Access Compliance Report

(Curb Ramps)

Intersection ID: 14556	Main Street: E_WORTHINGTON_AV	Cross Street: WINTHROP_AV	Location:	N
ADA ID: 4426418CE1E8	Ramp Type: Perp	Initial Pass/Fail: Fail	Overall Compliance: No	Severity Score: 22.5
Codes/Mitigation Info/Possible Solution		Field Measurements/Component Compliance

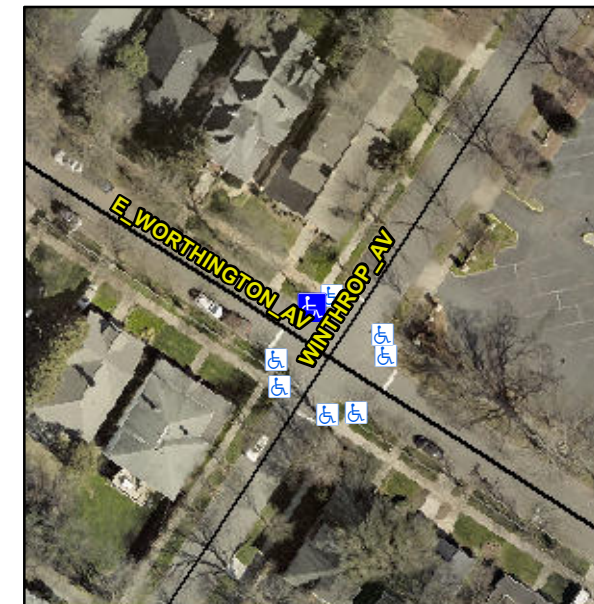
Not Found, R304.5.1, R304.2.2, R304.5.3

Compliance	Description	Data	Compliance	Description	Data
N/A	Ramp Length (in)	98.0	No	Ramp Slope (%)	9.3
No	Ramp Width (in)	42.0	No	Ramp XSlope (%)	4.1
N/A	Flare Type LT	N/A	N/A	Flare Type RT	N/A
N/A	Flare Slope LT (%)	N/A	N/A	Flare Slope RT (%)	N/A
N/A	Flare Traversable LT?	N/A	N/A	Flare Traversable RT?	N/A
N/A	Landing Length (in)	N/A	N/A	DWS Provided?	N/A
N/A	Landing Width (in)	N/A	N/A	DWS Contrast?	N/A
N/A	Landing Slope (%)	N/A	N/A	DWS Length (in)	N/A
N/A	Landing X Slope (%)	N/A	N/A	DWS Full Width?	N/A
N/A	Landing Curb? (Y/N)	N/A	N/A	DWS Offset (in)	N/A
N/A	Shared Landing?	N/A			
N/A	Gutter Ponding?	N/A	N/A	Gutter Slope (%)	N/A
N/A	Gutter Lip Ht (in)	N/A	N/A	Gutter X Slope (%)	N/A
N/A	Painted X Walk1?	No	N/A	Painted X Walk2?	N/A
	X Walk 1 Direction	To SW		X Walk 2 Direction	N/A
N/A	X Walk 1 Width (in)	N/A	N/A	X Walk 2 Width (in)	N/A
	X Walk 1 Slope (%)	3.9		X Walk 2 Slope (%)	N/A
	X Walk 1 X Slope (%)	0.4		X Walk 2 X Slope (%)	N/A

Remove & Replace Entire Ramp.
